SK-RFI3460R00-E265

DETAILS
TOWER AND SUSPENSION CABLE
TOWER POWER AND LIGHTING

SK-RFI3460R00-E337
R. GARCIA AUGUST 20, 2013

SK-RFI3460R00-E337C

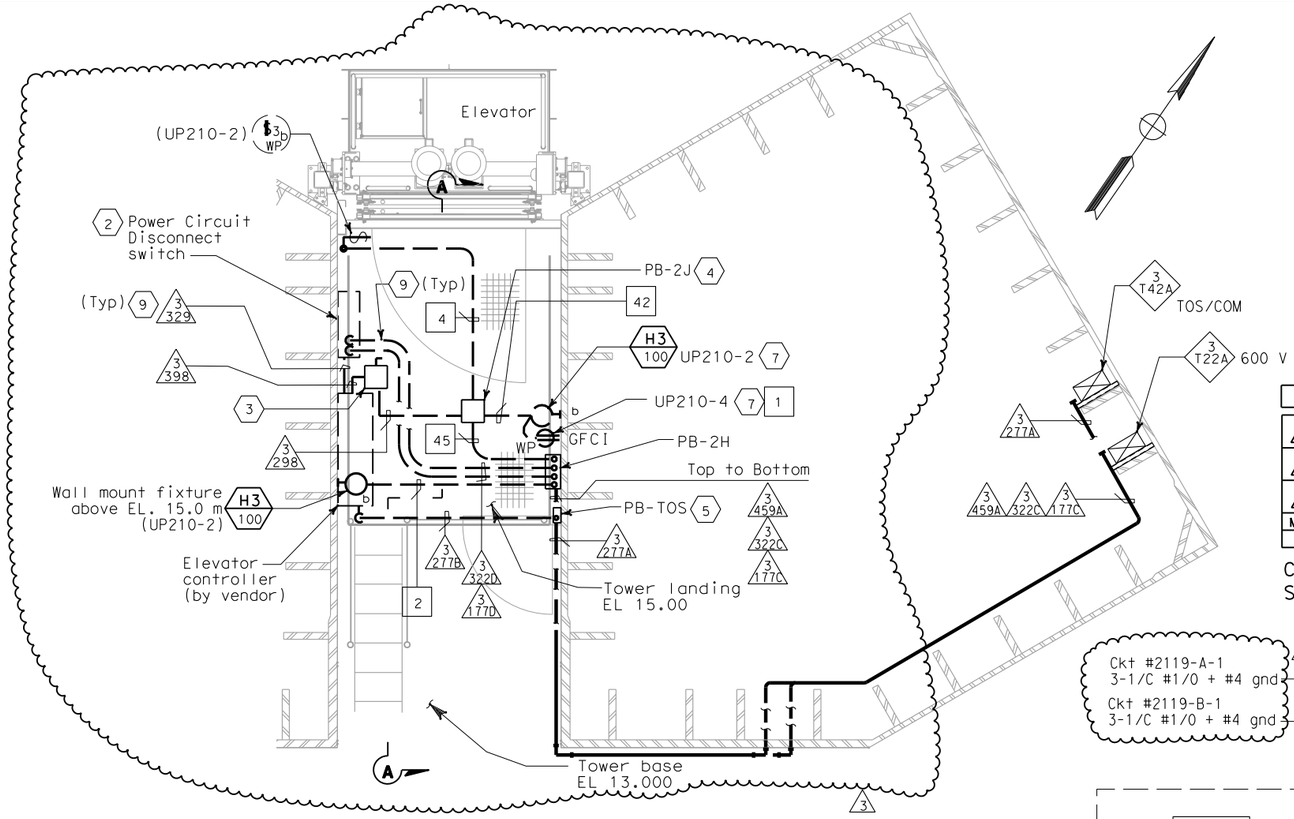
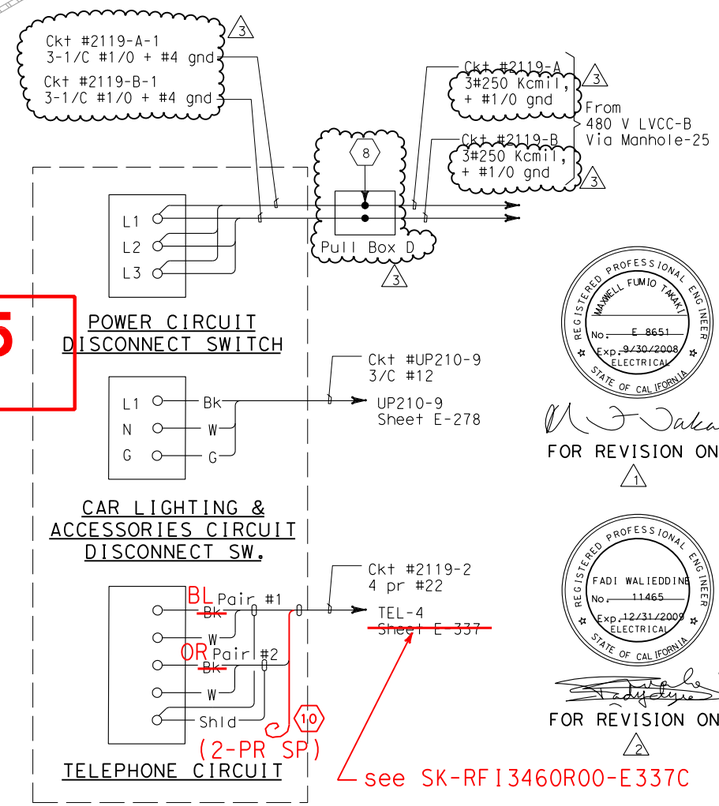
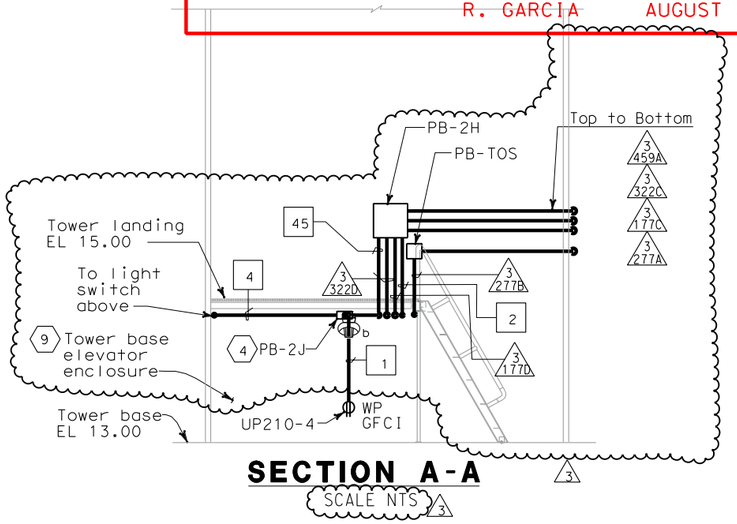
1. Deleted.
2. 480 V, 3 Ø, 100 A, non-fused disconnect switch for elevator pit motor. Use liquid tight flexible conduit from disconnect switch to the motor.
3. 120 V single pole single throw disconnect switch for elevator lighting and fan. Mounted DS between power circuit disconnect switch and controller.
4. Mounte below Elevation 15.0 m grating. 3
5. PB-TOS for telephone communication lines.
6. 3
7. For additional lighting and receptacles at EL. 9.00 M, see sheet E-266.
8. Splice conductors inside pull box "PB-D" see drawing E-264A
9. Conduit routing inside elevator enclosure may be adjusted to suit field condition.
10. Spare cable or conductor ends shall be coiled and taped. 3

DETAILS
SCADA REMOTE TERMINAL UNIT SYSTEM
~~#TEL-4~~ TERMINAL CONNECTION DIAGRAM

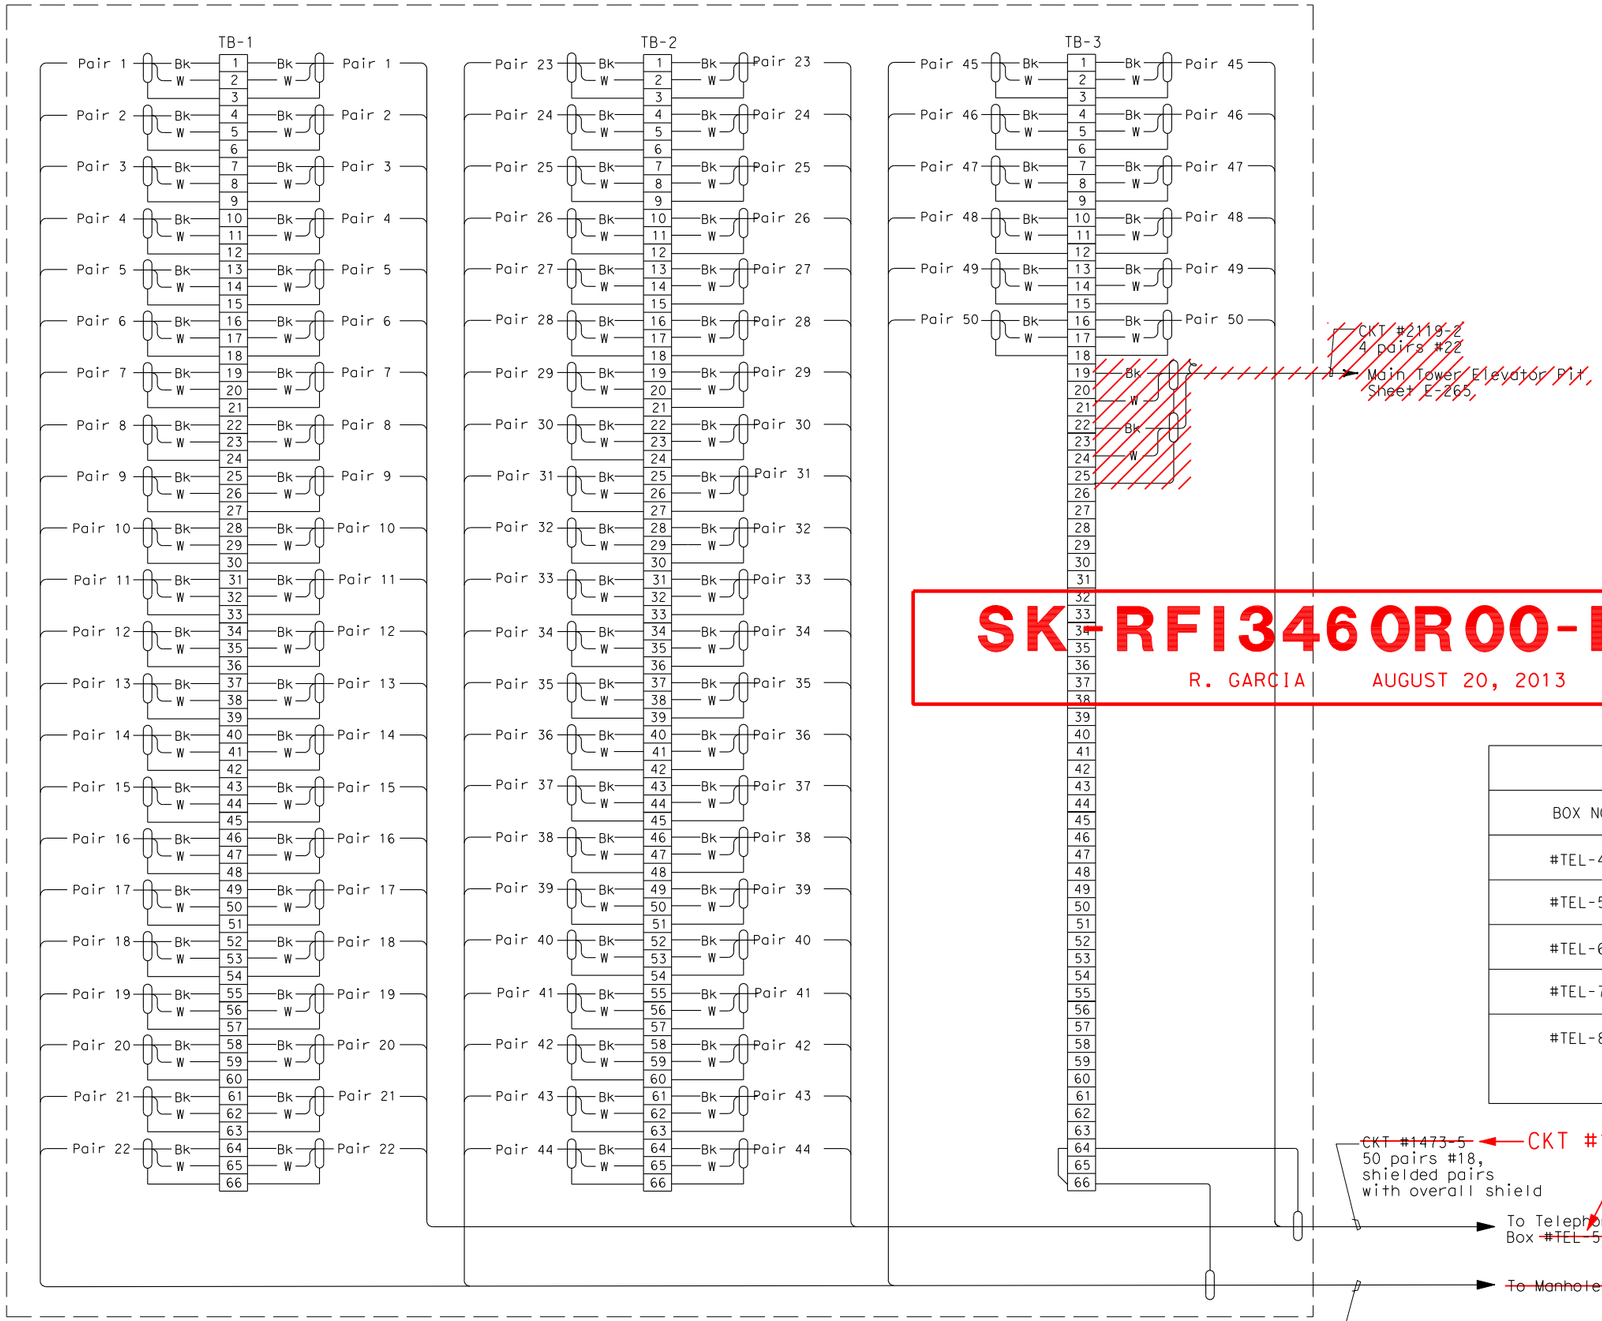
1. For cable/circuit number, see Table A.
2. Use Table A in conjunction with cable block diagram sheet E-317.
3. ~~The Contractor shall extend and coil 5 meters of cable in Manhole-27. All cables shall be tagged with circuit numbers as shown. For location of Manhole-27, see sheet E-11.~~

BOX NO.	CABLES		REMARKS
#TEL-4	~~1473-4~~	~~1473-5~~	For cable interface, see SK-RFI3460R00-E337C
#TEL-5	~~1473-5~~	~~1473-6~~	For cable interface, see SK-RFI3447R00-E337D of RFI 3447R00 response
#TEL-6	1473-6	1473-7	
#TEL-7	1473-7	1473-8	
#TEL-8	1473-8	—	
	1473-10	2473-10	For cable interface, see sheet E-316, sheet notes 1 and 2

Shown for ~~#TEL-4~~, See Table A for other terminal boxes

#TEL-6

#TEL-6

DETAILS
SCADA REMOTE TERMINAL UNIT SYSTEM
#TEL-4 TERMINAL CONNECTION DIAGRAM

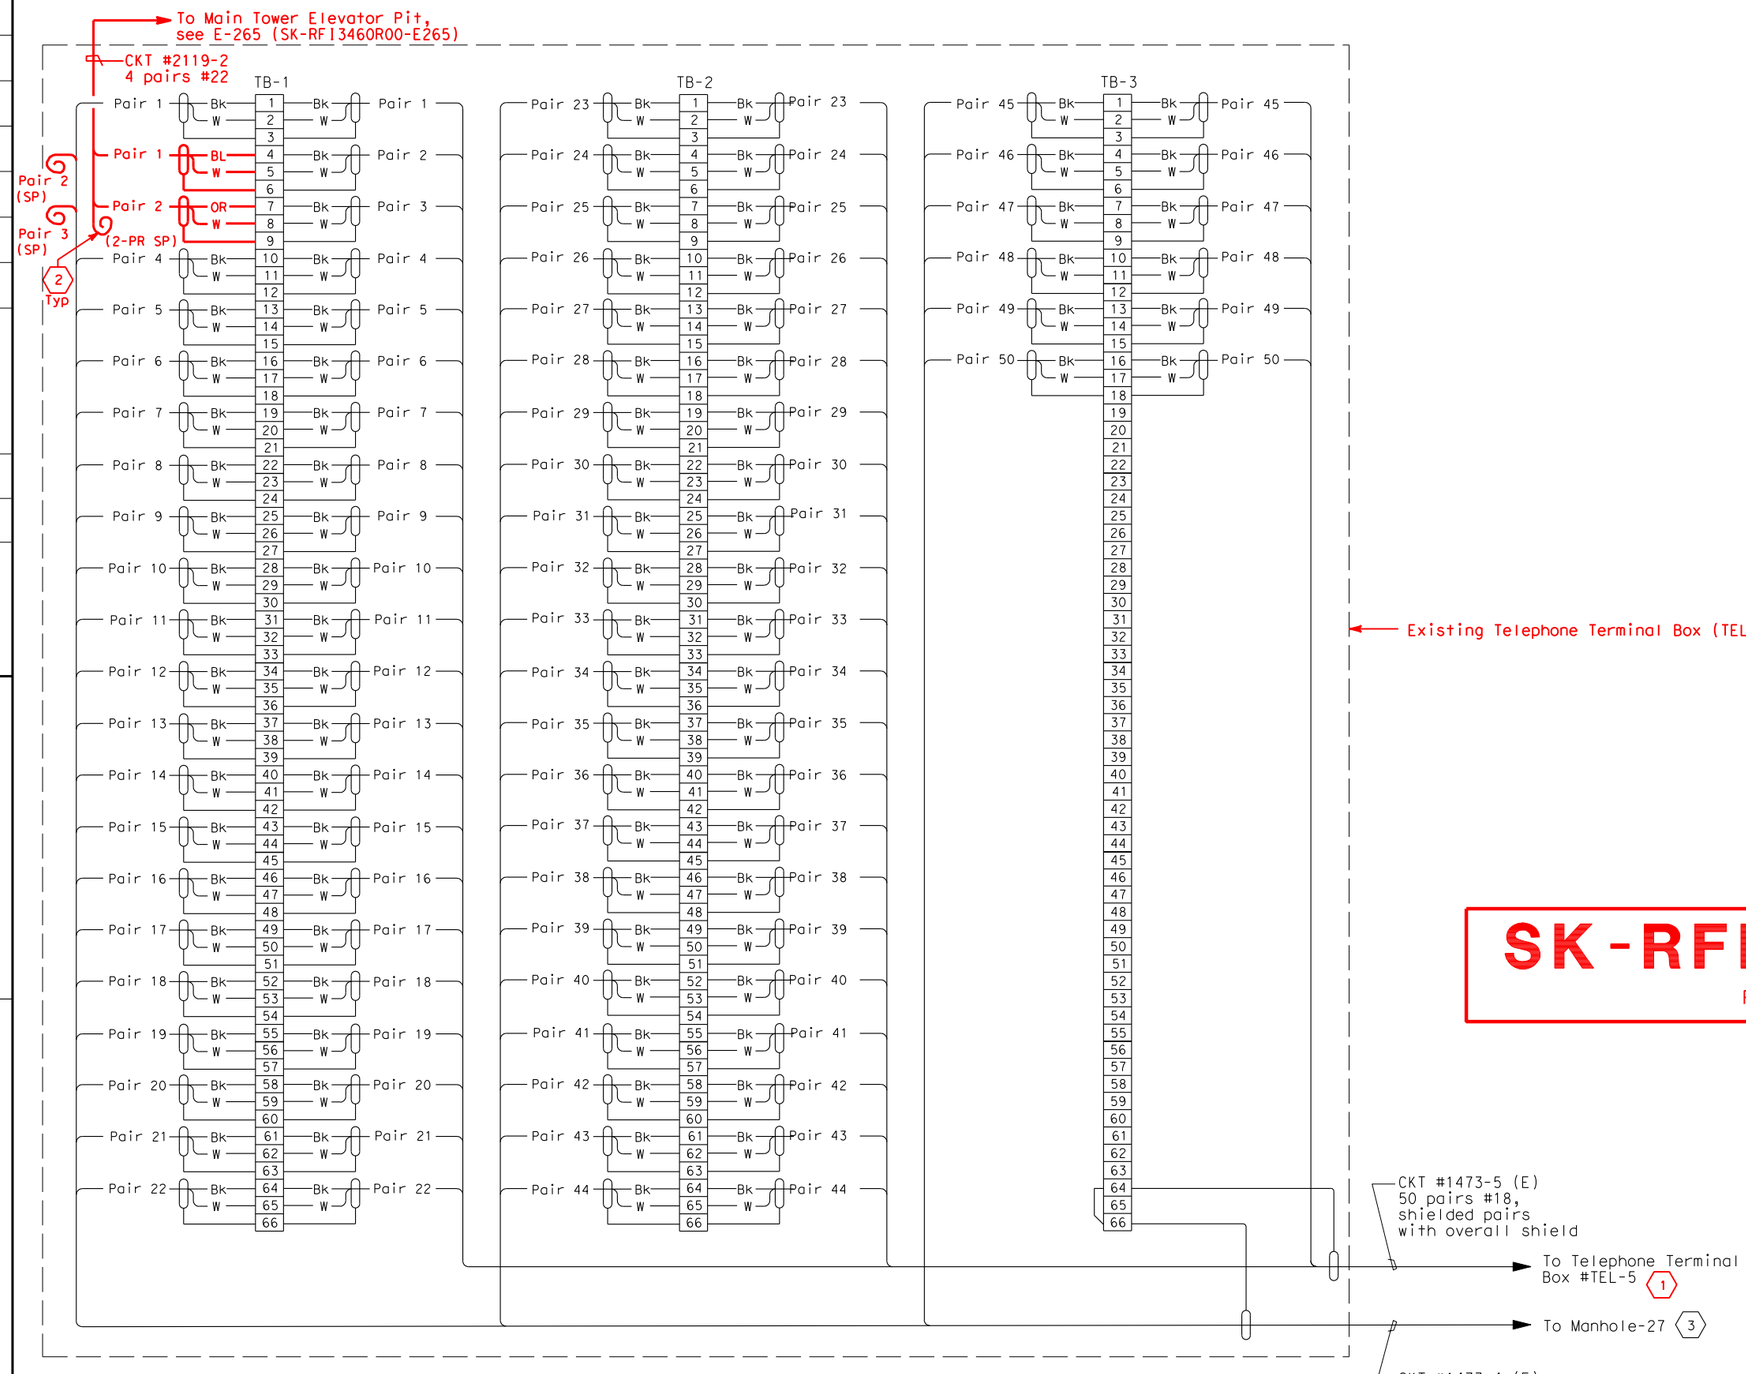
1. For terminal connection diagram and continuation to TEL #5, see SK-RFI3447R00-E337D of RFI-3447R00 response.
2. Spare cable or conductors ends shall be coiled and taped.
3. The Contractor shall extend and coil 5 meters of cable in Manhole-27. All cables shall be tagged with circuit numbers as shown. For location of Manhole-27, see sheet E-11.
